MEMORANDUM

TO: District of Columbia Board of Zoning Adjustment
FROM: Stephen Cochran, Case Manager
 Joel Lawson, Associate Director Development Review
DATE: November 24, 2015

SUBJECT: BZA No. 19113 –Special Exception and Variance and relief for a new residential building at 1000 South Capitol Street, S.E.

Figure 1. Ground Floor and Roof Level Plans, Showing Areas for Which Relief is Requested. Red arrows indicate roof structure setback requests. Green arrows indicate side yard requests.

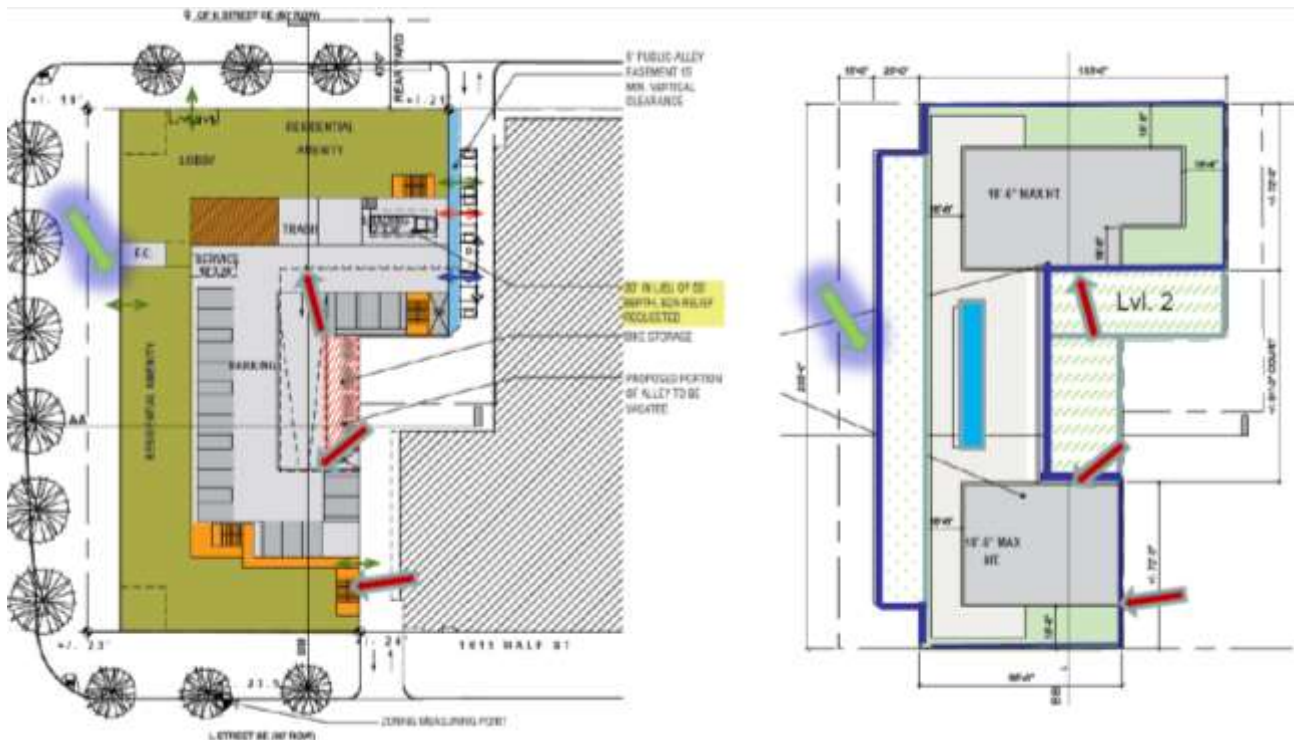
Per §§3104.11 and 411.11, the Applicant requests special exceptions to allow for roof structures that do not meet the single enclosure requirement of §411.3 and are not setback from all exterior walls a distance equal to their height above the roof upon which they are located. §411.11 allows for the BZA to grant a special exception from the location, design, number and other aspects of roof structures regulated under §§411.3 through 411.6, where operating difficulties, size of building lot or other conditions relating to the building or surrounding area would tend to make full compliance unduly restrictive, prohibitively costly or unreasonable.

Yes. The applicant has voluntarily complied with the South Capitol Street design regulations first established for the Capitol Gateway Overlay to the south of this site. At the time this report was written, the Zoning Commission, with a positive recommendation from the National Capitol Planning Commission, had given preliminary approval to extend these regulations to all of South Capitol Street between I-395/695 and the baseball park. If given final approval, they will required a 15-foot setback from the South Capitol Street property line on the applicant's site and will require the upper stories of the building to be setback at a 1:1 ratio above 110 feet. Under existing

regulations, the building is already subject to 1:1 roof structure setbacks from adjacent streets. The design's respect for the South Capitol Street guidelines tends to push service cores and rooftop amenities farther east, towards the alley, than would otherwise be the case. Together with the "C"-shape of the building's residential floors, which optimizes the light and air available to apartments, the roof area available for mechanical penthouses is limited. The building requires two mechanical cores. Combining them into a single structure would increase the mass and prominence of the roof structure and could result in a need from additional setback relief from the building's street facades.

The special exception would enable the applicant to meet the proposed building's mechanical and, circulation requirements, as well as the 1:1 setback regulations from the streets, including a setback of over 50 feet from the South Capitol Street property line, to minimize the visibility of the penthouses from public ways.

Yes. L Street is the official front of the building. The building could have been designed with no side yards and complied with existing zoning regulations. However, this would have resulted in no setback from South Capitol Street. As noted in the analysis of the special exception relief, the building is designed to respect the preliminarily-approved regulations that would require a 15-foot setback along South Capitol Street and an additional 1:1 setback for any portion of the building exceeding 110-feet in height. The Applicant states the narrow 15' alley access constrains large truck access to the property and the voluntary compliance with South Capitol Street guidelines create a

Yes. The intent of the side yard regulations is to provide light and air to adjacent properties and since the South Capitol Street right-of-way abuts the property, impacts are minimal. Additionally, the side yard is not currently required for this particular property, and is provided only to continue the 15-foot setback from South Capitol Street already established within the CG overlay.
